Rezoning Transportation Analysis

Petition Number: Zoning Petition #2021-004

General Location Identifier: Tax ID 08117410

Date	Description
02-25-2021	First Review (WB)
03-25-2021	Second Review (WB)

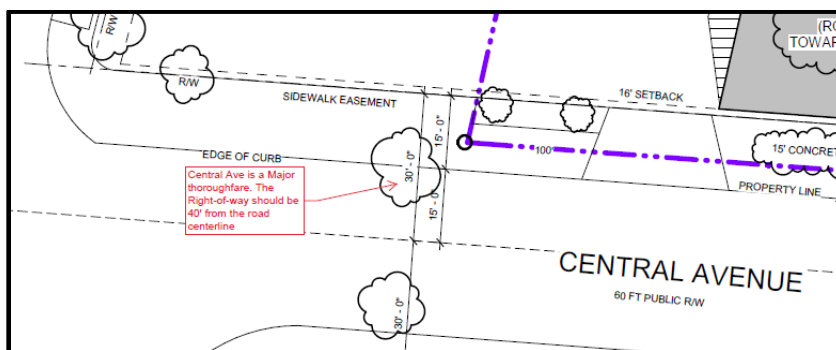
4. Revise site plan and conditional note(s) to commit to dedicating 40' right-of-way from the Central Avenue road centerline. The site plan shall label and dimension the right-of-way from the road centerline.

Revised based on site plan dated 03/15/2021.
